CITY OF LA VISTA
PLANNING DIVISION

RECOMMENDATION REPORT

CASE NUMBERS: PPUD22-0003;

RE: Planned Unit Development Amendment – Initial Review Letter
Lot 2 Southport East Replat Two

C4.0

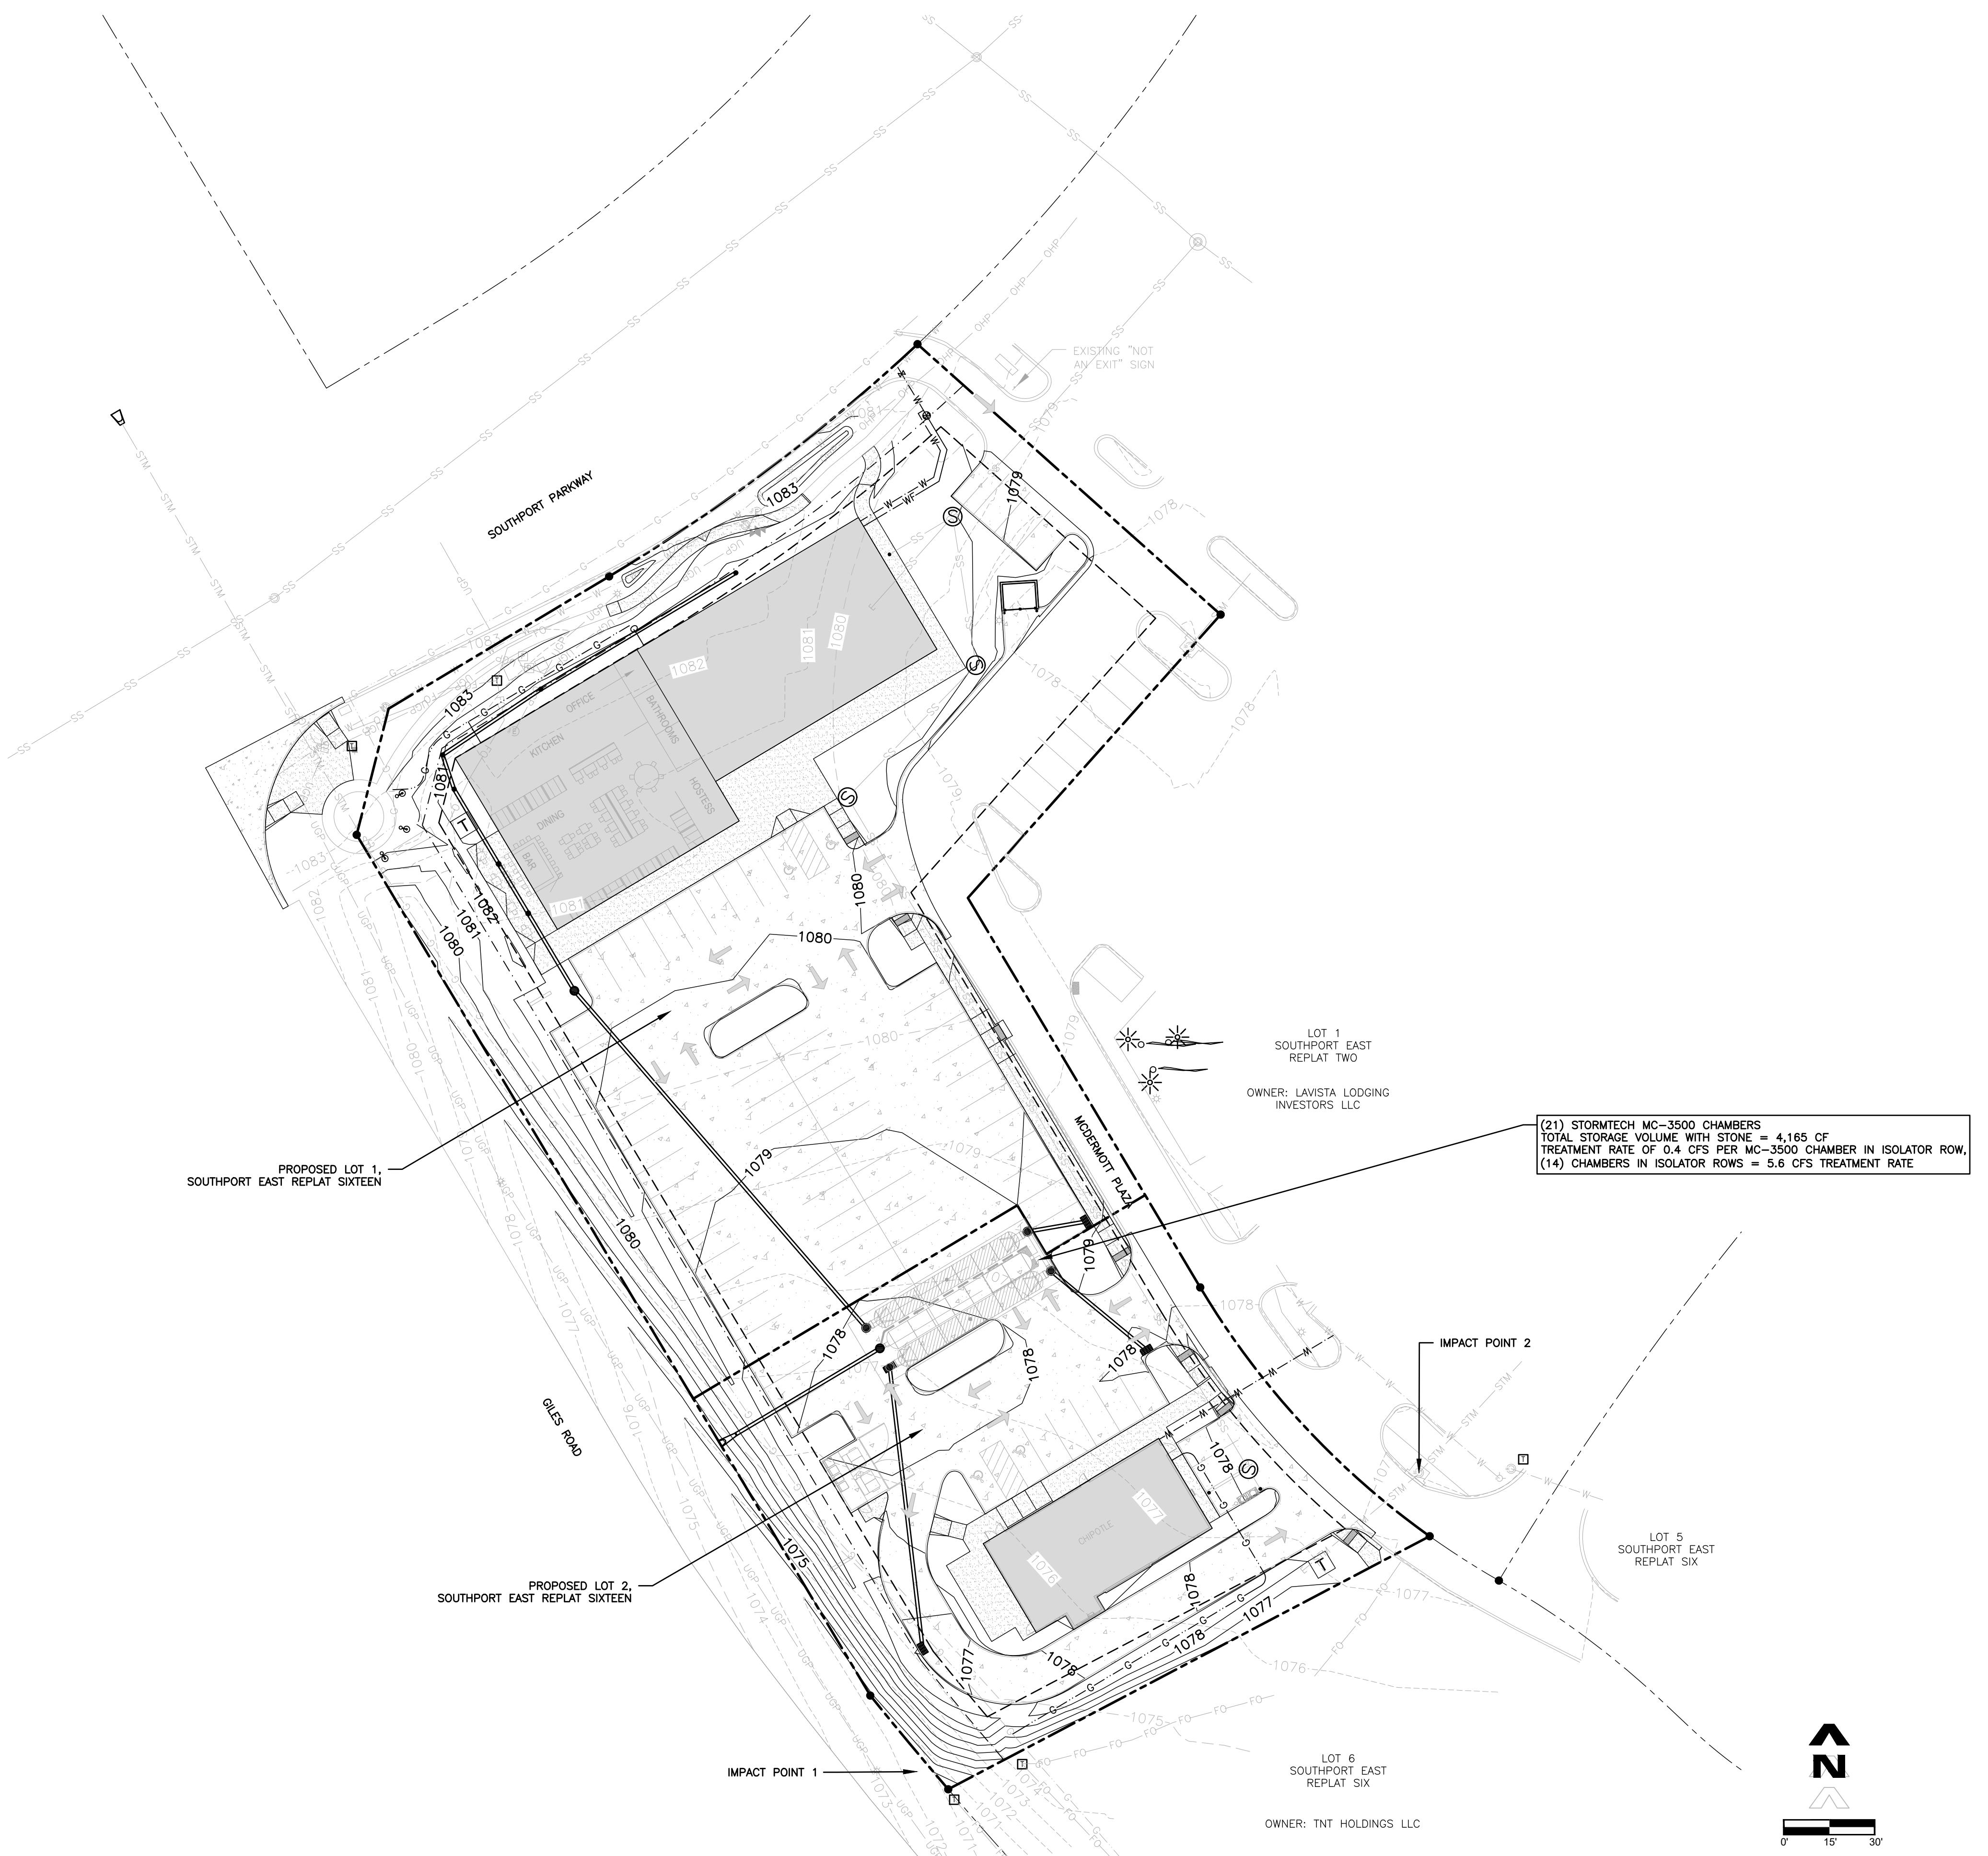
Sheet C4.0

25. Pertaining to Section 5.15.04.08 of the La Vista Zoning Ordinance, the proposed landscaping plan is currently under review by the City's third-party design review architect. Landscaping for the development will need to meet the requirements of the Southport East Design Guidelines. Review comments will be provided when they are available.
26. Not all utility boxes are depicted along Southport Parkway. Please depict all boxes in the landscaping plan and related vegetative screening. Access doors to boxes cannot be blocked.

27. The landscaping plan does not depict the existing Center Identification Sign for the subdivision. Please depict this sign and adjust the location of any landscaping, as necessary.
28. No signage is depicted within any of the plans in this PUD plan set. Proposed ground monument signage locations, including setbacks, need to be depicted and landscaping should be adjusted accordingly.
29. Please make any necessary adjustments to the Landscaping Plan that may result from the introduction of the light poles.
30. Berming along street frontages is a requirement as per the Southport East Design Guidelines. Berming should be reflected in the PUD Grading Plan and the PUD Landscaping plan.
